Water
 May 2019

**ALBERTA TRANSPORTATION SPRINGBANK OFF-STREAM RESERVOIR PROJECT
 RESPONSE TO NRCB AND AEP SUPPLEMENTAL INFORMATION REQUEST 1, JULY 28, 2018**

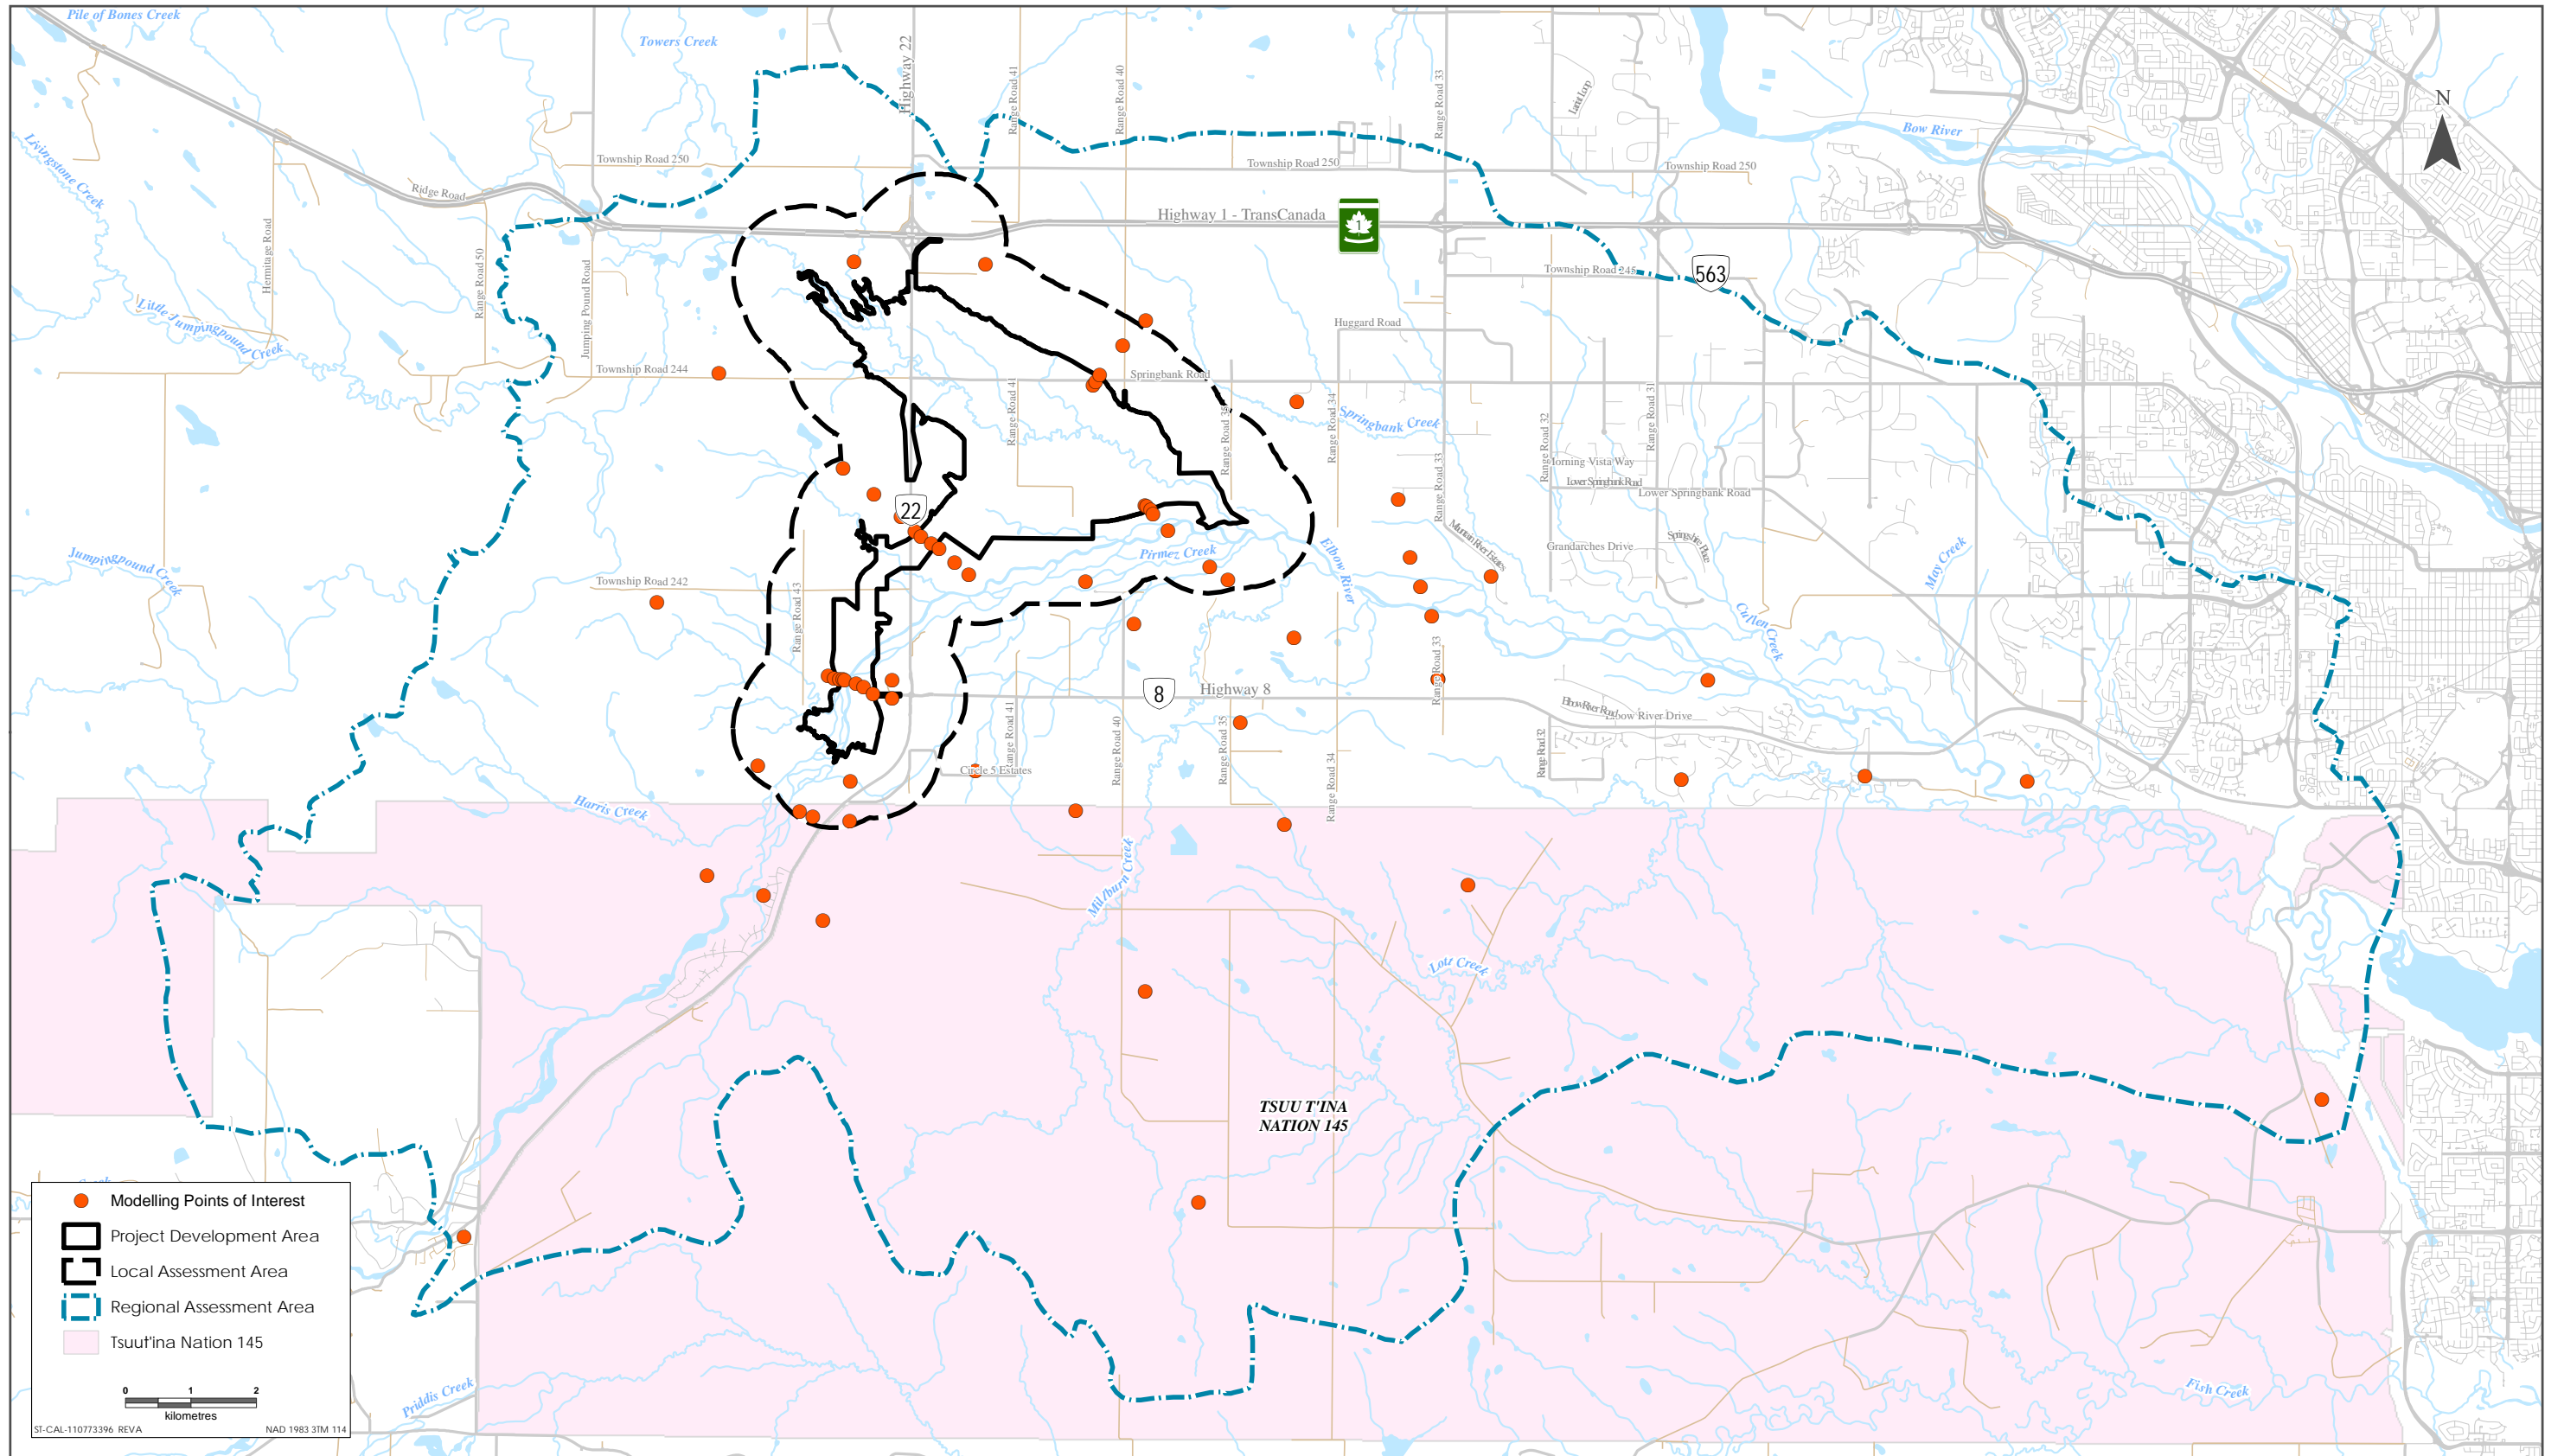
Last paragraph: potential locations of interest were identified, *up to near the LAA boundary*. Two points were within the RAA (shown on Figure 5-5).

- a. Points of interest have been updated in the Hydrogeology TDR Update, Section 5.4 (see the response to IR42, Appendix IR42-1). A total of 67 points were chosen across the groundwater LAA and expanded RAA to evaluate potential effects on groundwater levels from the construction and operation of the Project. The points are presented in Figure IR224-1 and were chosen as follows:

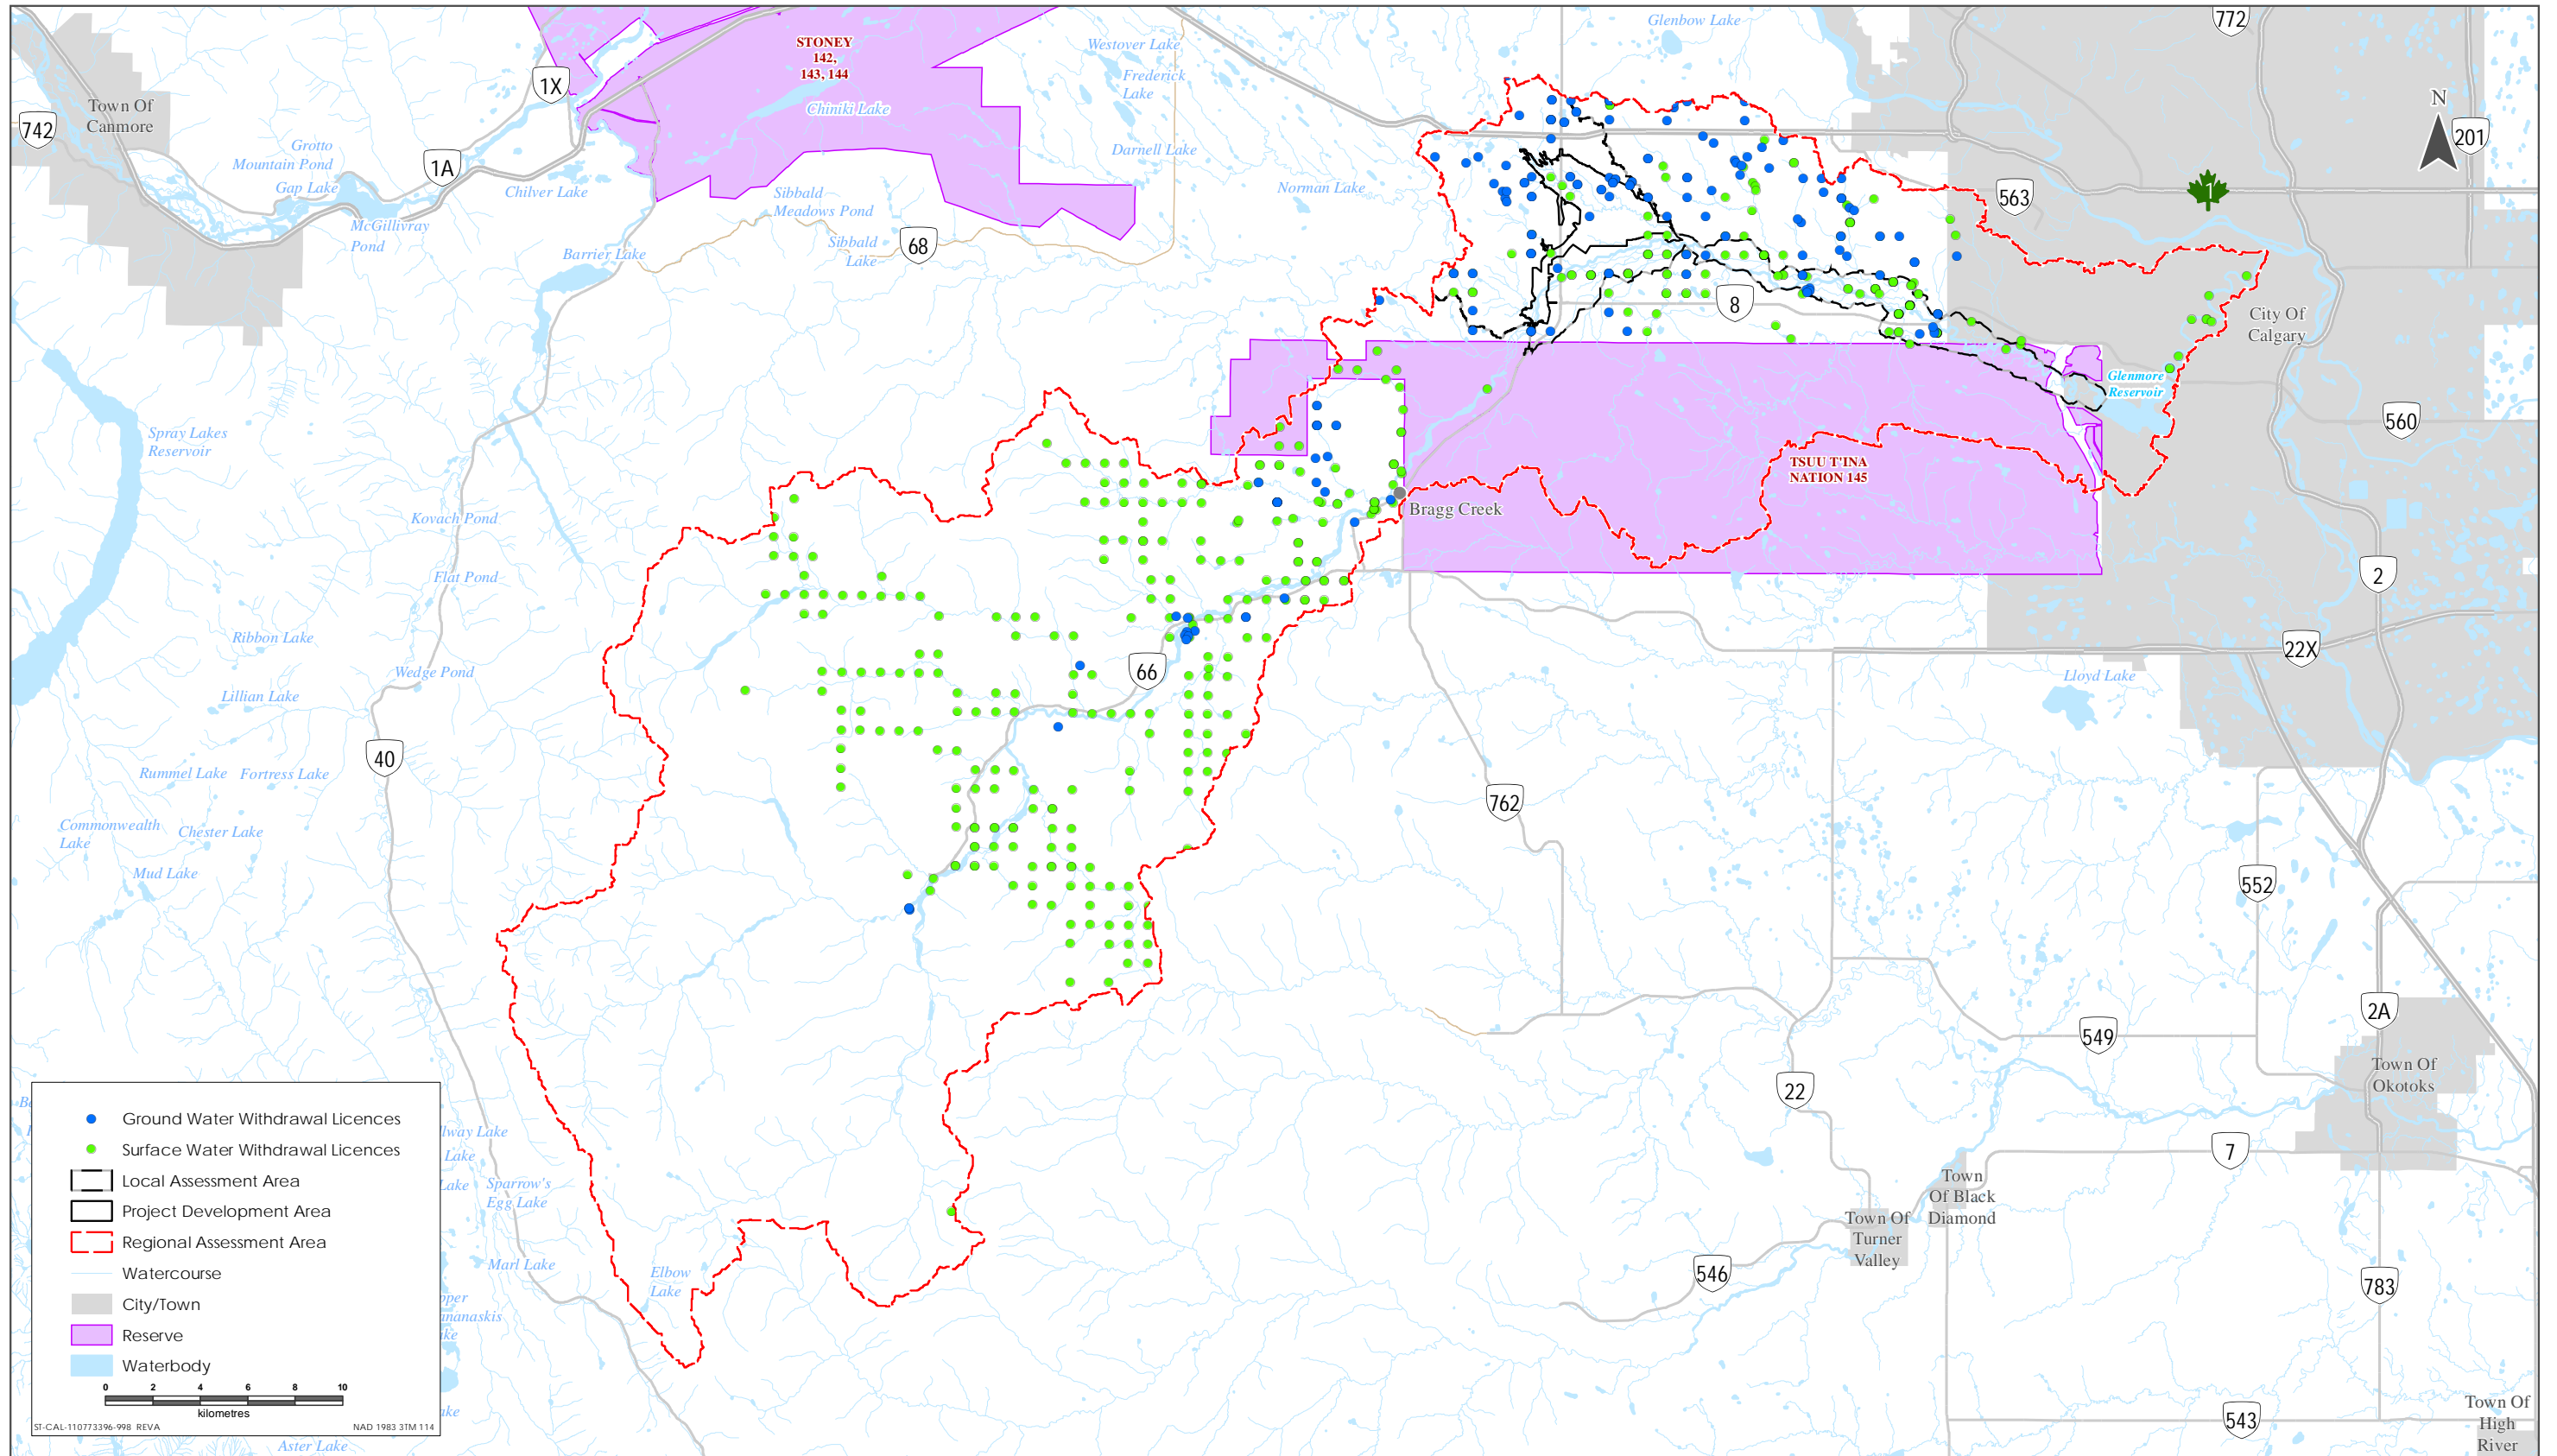
- a. Include map showing locations of the water licences in the LAA and RAA (LAA and RAA boundaries as per Figure 6-1 in Volume 3A_S06).
- b. Provide more detail on each of the licences including the types of licences, source of water, location etc.
- c. Describe whether these water licences will be affected due to the project and identify the affected licences.
- d. What will be the mitigation measures be for the affected licences?

- a-b. The location of water withdrawal licences and allocations within the hydrology RAA is provided in Figure IR274-1. The hydrology RAA is the Elbow River watershed. Appendix IR274-1 contains two tables, Table IR274-1 and Table IR274-2 that list all surface water and groundwater licences and allocations within the Elbow River watershed.
